SUSITNA HYDROELECTRIC PROJECT

REPORT ON SECOND SPECIALIST  
CONSULTANTS PANEL MEETING,  
BUFFALO, N.Y.

FEBRUARY 17 & 18, 1981

**Acres American Incorporated**  
1000 Liberty Bank Building  
Main at Court  
Buffalo, New York 14202  
Telephone (716) 853-7525

ALASKA POWER AUTHORITY	
SUBITNA HYDROELECTRIC PROJECT	
DEVIL CANYON	
DOUBLE CURVATURE ARCH DAM	
GEOMETRY	
DATE	REVISION
CH	APP
DESIGN	CONSTRUCTION
APPROVED	APPROVED
SIGNATURE	SIGNATURE
DATE	DATE

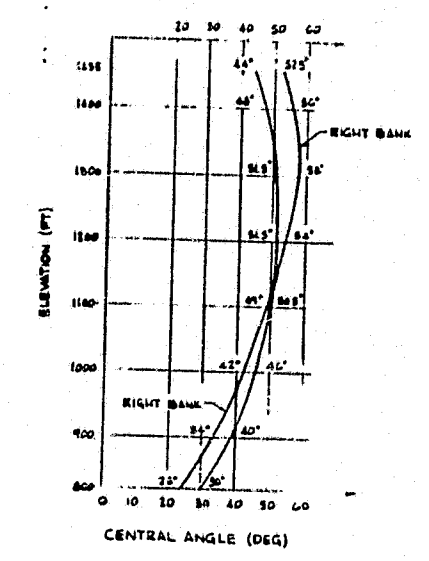
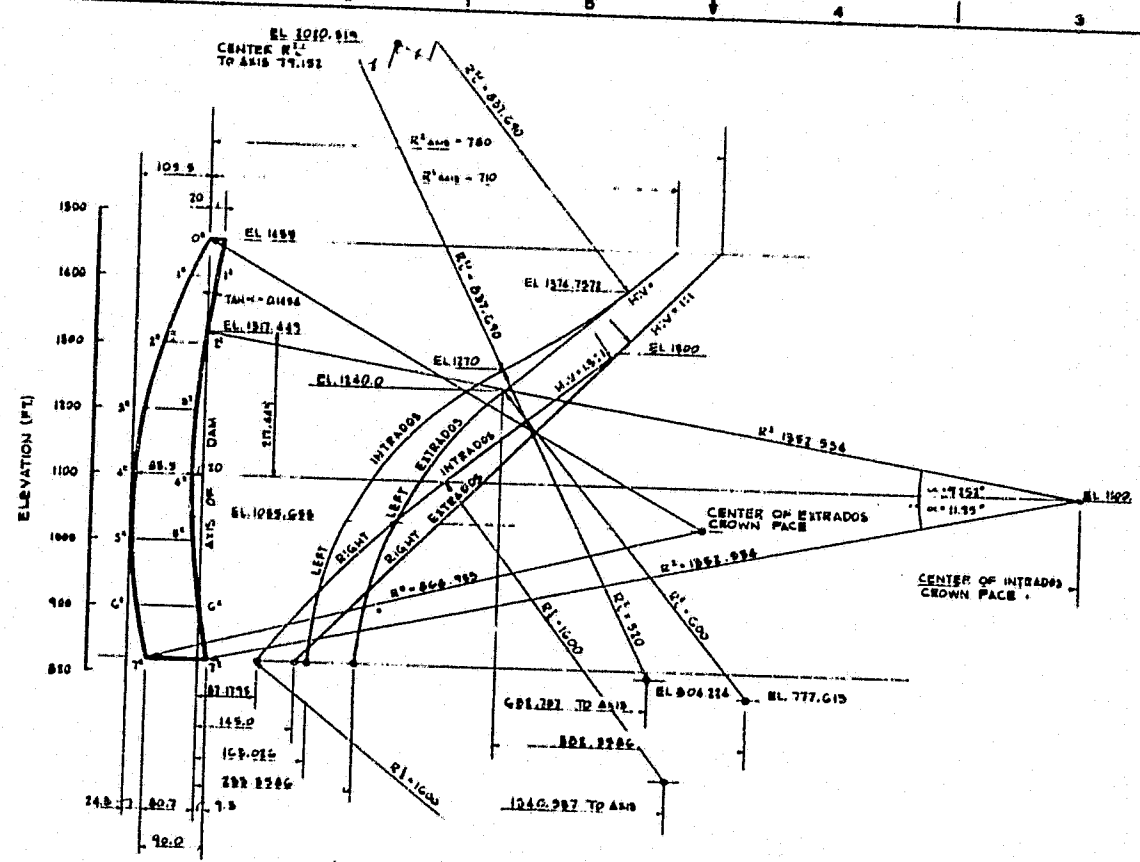
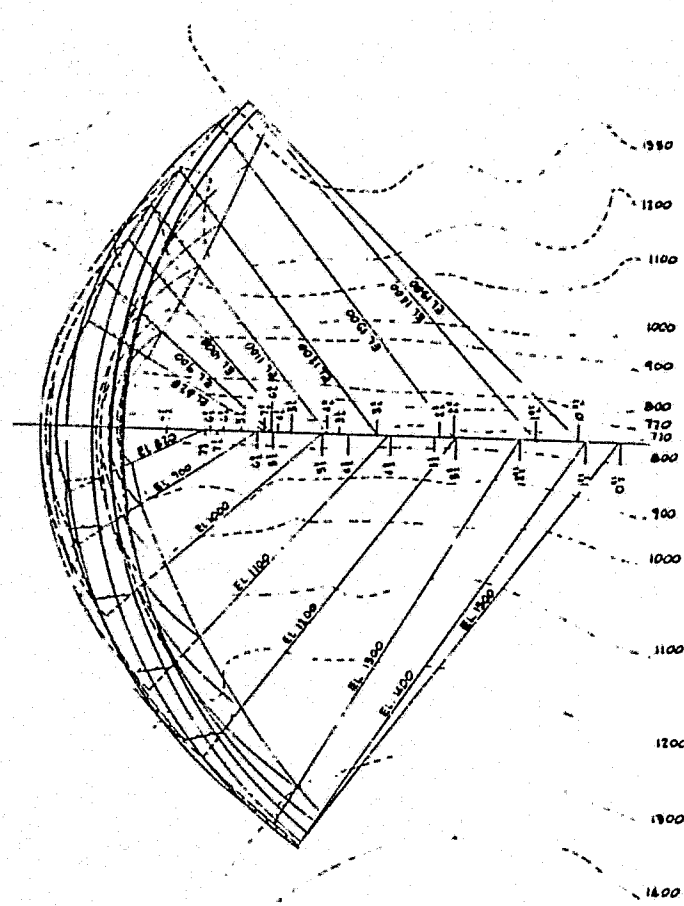
- Thin Arch Dam - geometry presented. Assymetrical arrangement gives better stress distribution in abutments.

SOUTHCENTRAL RAILBELT AREA, ALASKA  
SUPPLEMENTAL FEASIBILITY STUDY  
UPPER SUBITNA RIVER BASIN  
WATANA DAM  
SECTIONS

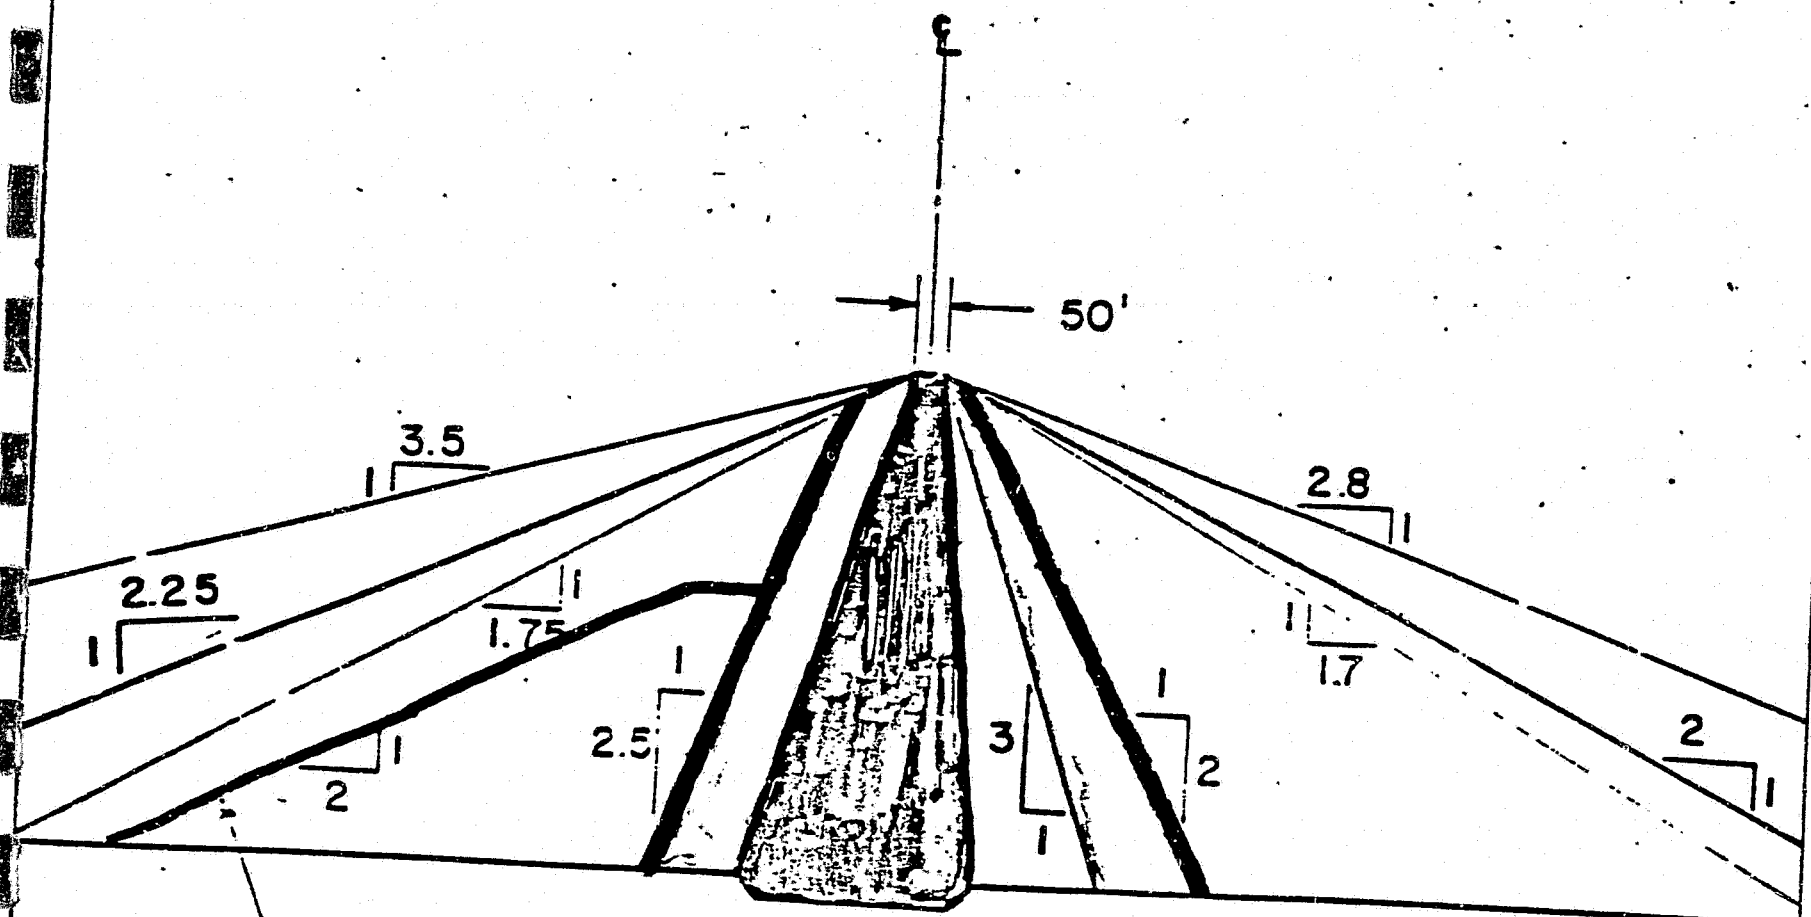
- Presentation of Watana embankment sections - original COE layout.
- Acres proposal for slight u/s - d/s slope on core. (see Attachment 3)
- Portion of u/s shell constructed of cobbles. U/s - d/s slopes of shells vary from 1.75:1 to 3.5:1 u/s and 1.7:1 to 2.8:1 d/s - assume alluvium u/s to be used in shell - use all available gravel shells.
- Dr. Seed - has suggested core should be sloped more upstream. Also recommended making slopes similar to Oroville - for seismic shaking. This increases volume and cost.

R. Peck - definitely rather see more gravel in upstream shell than rockfill, have to see what material is available and go from there. Beneficial to compensate for steeper slopes with better compaction. If flat slopes - don't. Suggest steeper slopes in section of cobbles in upstream shell from that shown which will tend to crack. Steeper section will have more tendency to crack further upstream.

A. Hendron - like idea of leaving core where it is. More stable than sloping upstream.

Fig. 1  
Maximum Embankment Section — Oroville Dam.  
Barrage d'Oroville — Coupe du massif.

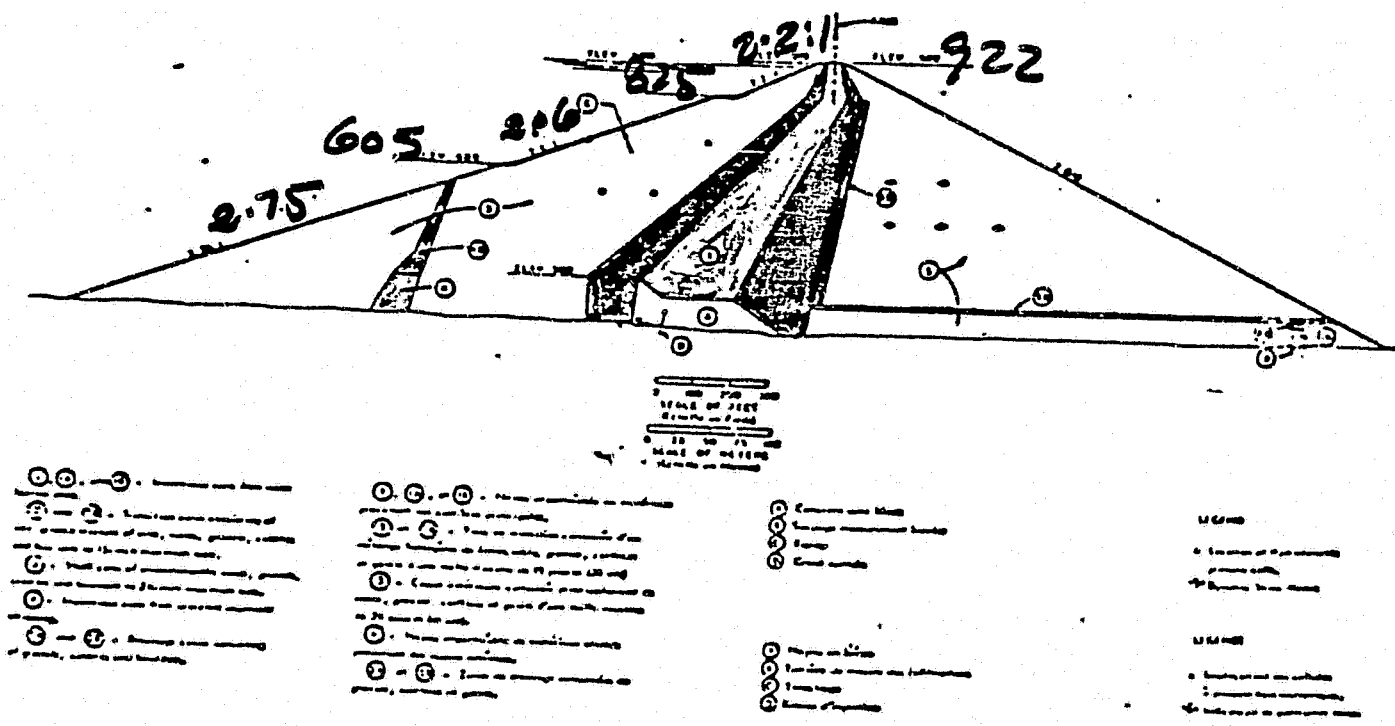
R. Peck - don't want to duplicate core sections of Oroville - Acres section better in that respect.
